## Note / Memo

To: Suffolk County Council  
From: Royal HaskoningDHV  
Date: Friday, 20 March 2020  
Copy:  
Our reference: PB8301-RHD-ZZ-XX-NT-Z-0001  
Classification: Project related

**Subject: Pedestrian Crossing Assessment Associated with the Proposed Residential Led Mixed-Use Development at Land near Haverhill, Wilsey Road, Little Wrating, Suffolk (Planning Application Reference DC/19/0834/RM)**

Insert 1.1: Proposed Pedestrian Crossing Locations

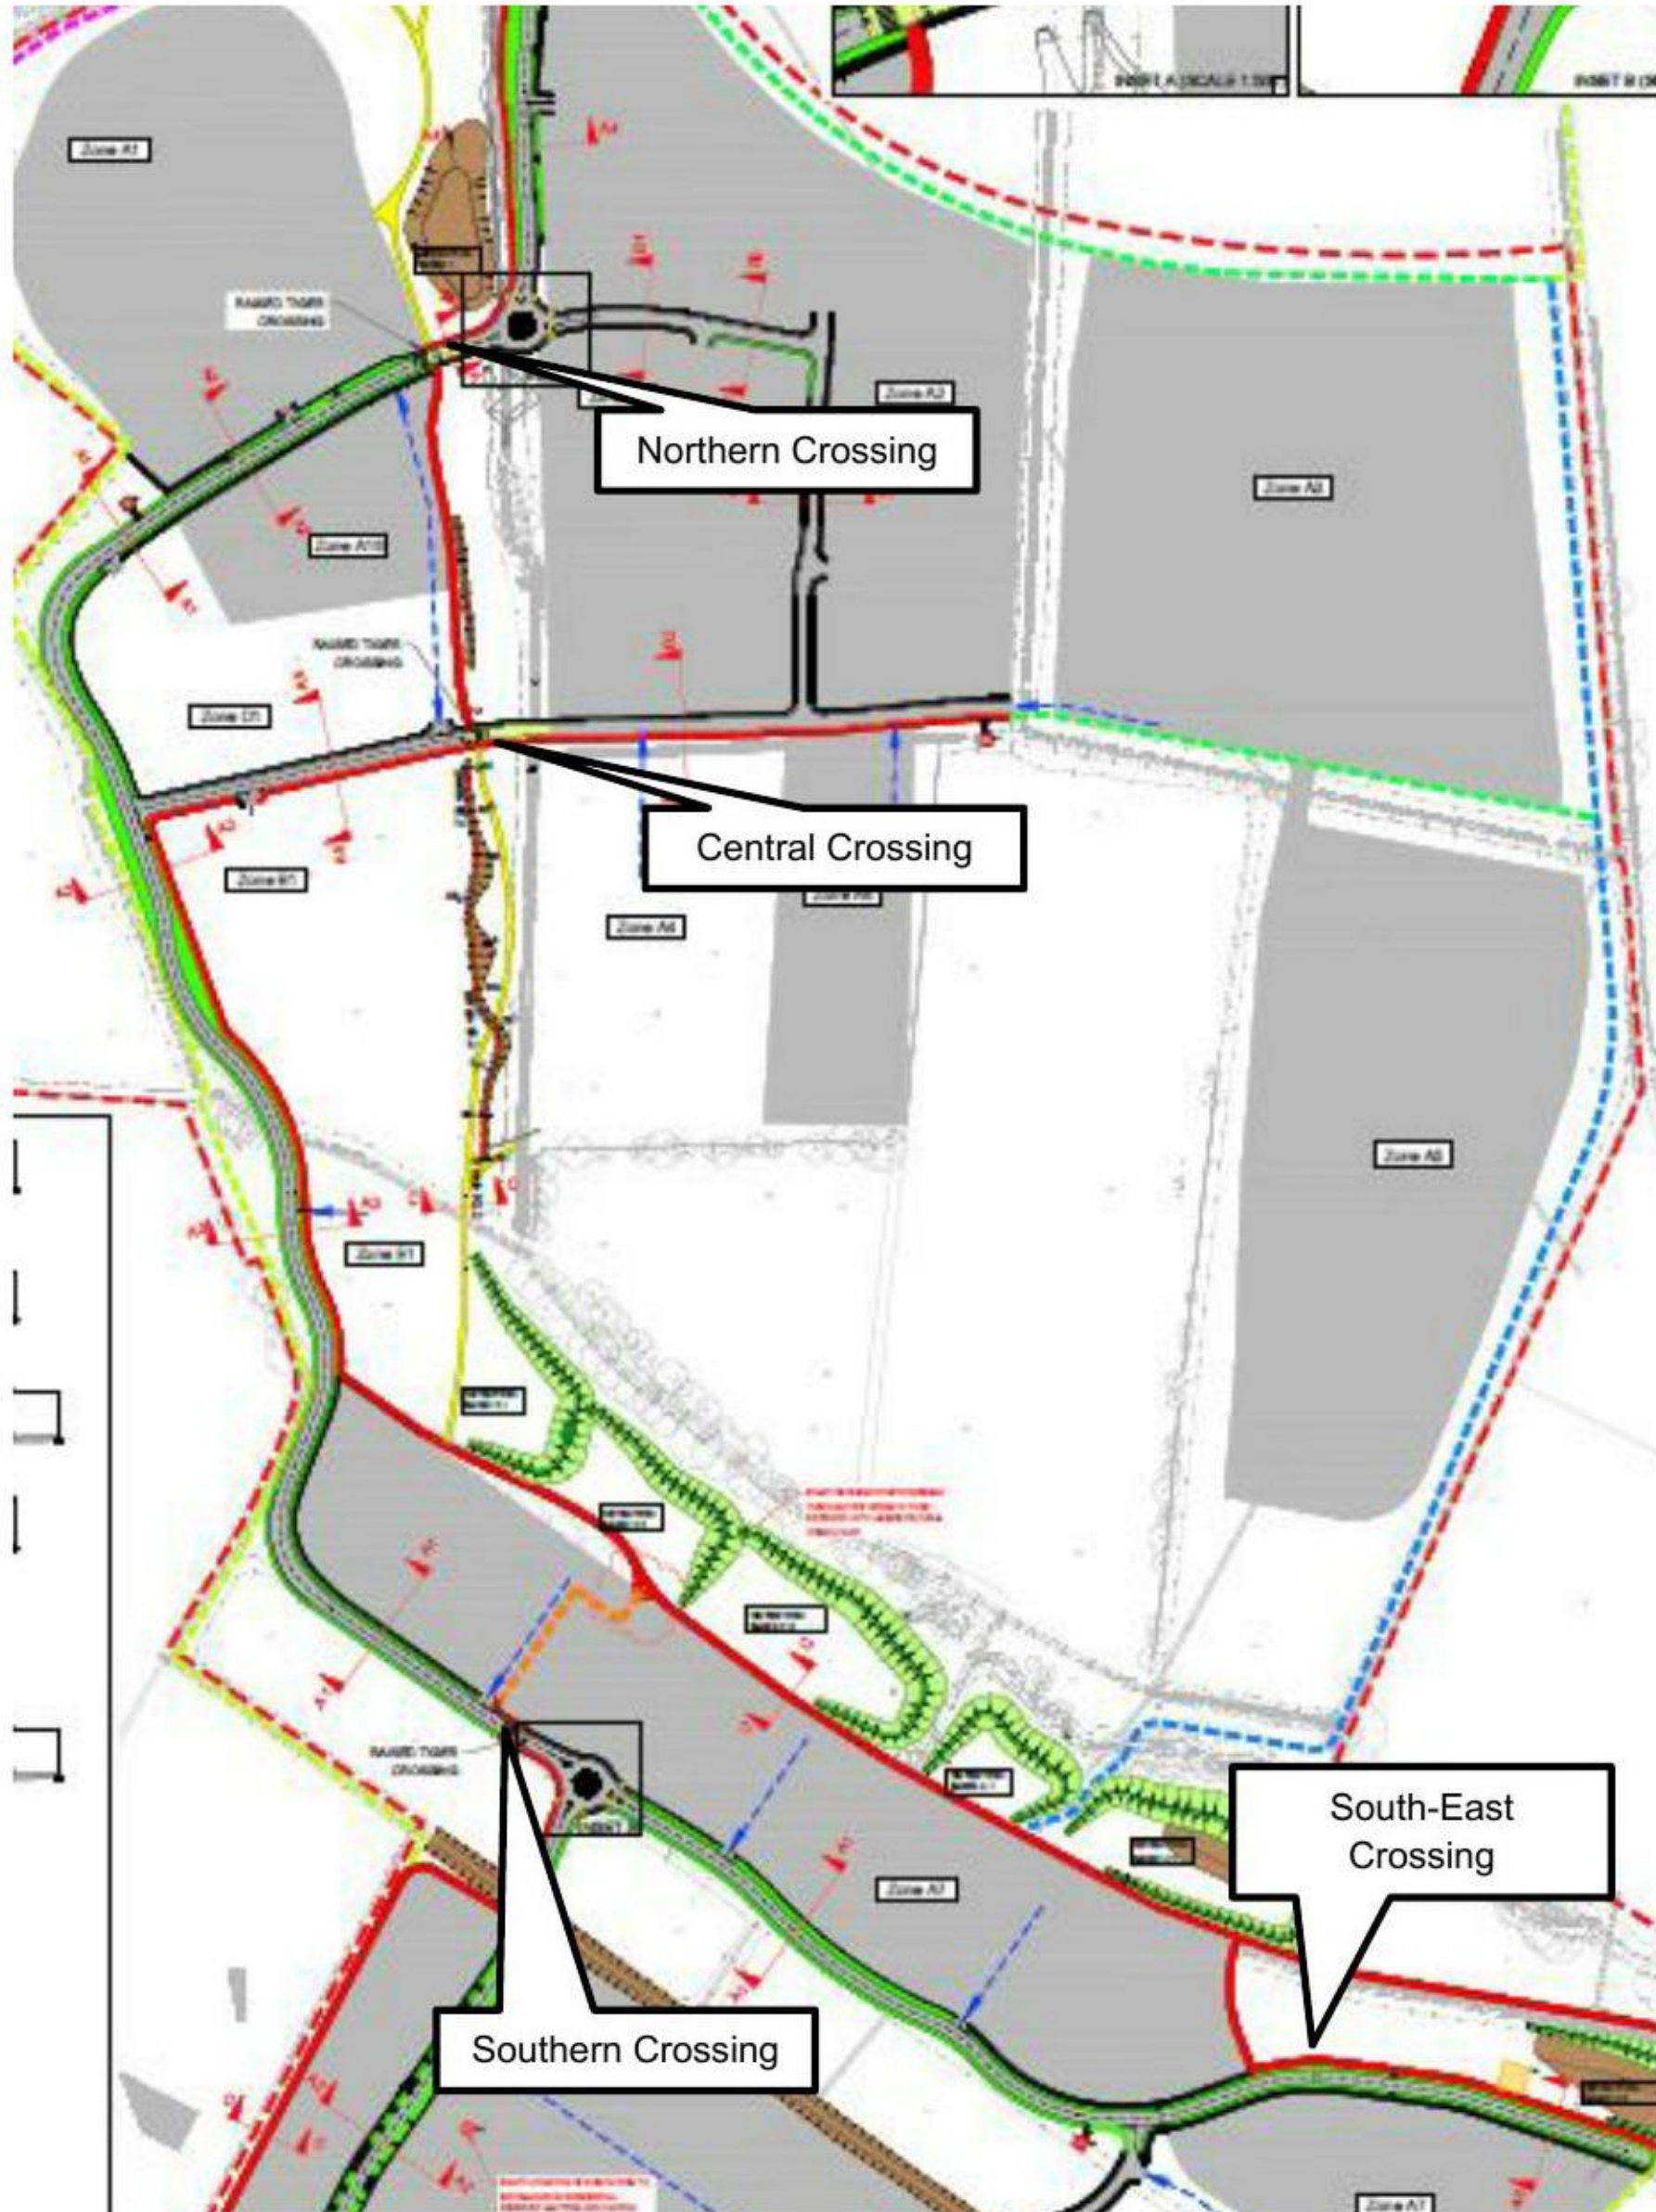
*"The spine road design indicates several Zebra or Tiger (cycle Zebra) or uncontrolled crossing points. The proposed traffic flows and potential for higher speeds will not enable this type of crossing to operate safely. Given the traffic flows expected through the site formal push button Puffin or Toucan crossings will be required on key pedestrian and cycle desire lines."*

1.1.3 Three pedestrian crossing points are proposed on the proposed internal highway network. The proposed crossings would facilitate north-south pedestrian and cycle movements and would be provided in the form of Tiger (cycle Zebra) crossings. The locations of the proposed crossings are indicated in **Insert 1.1**.
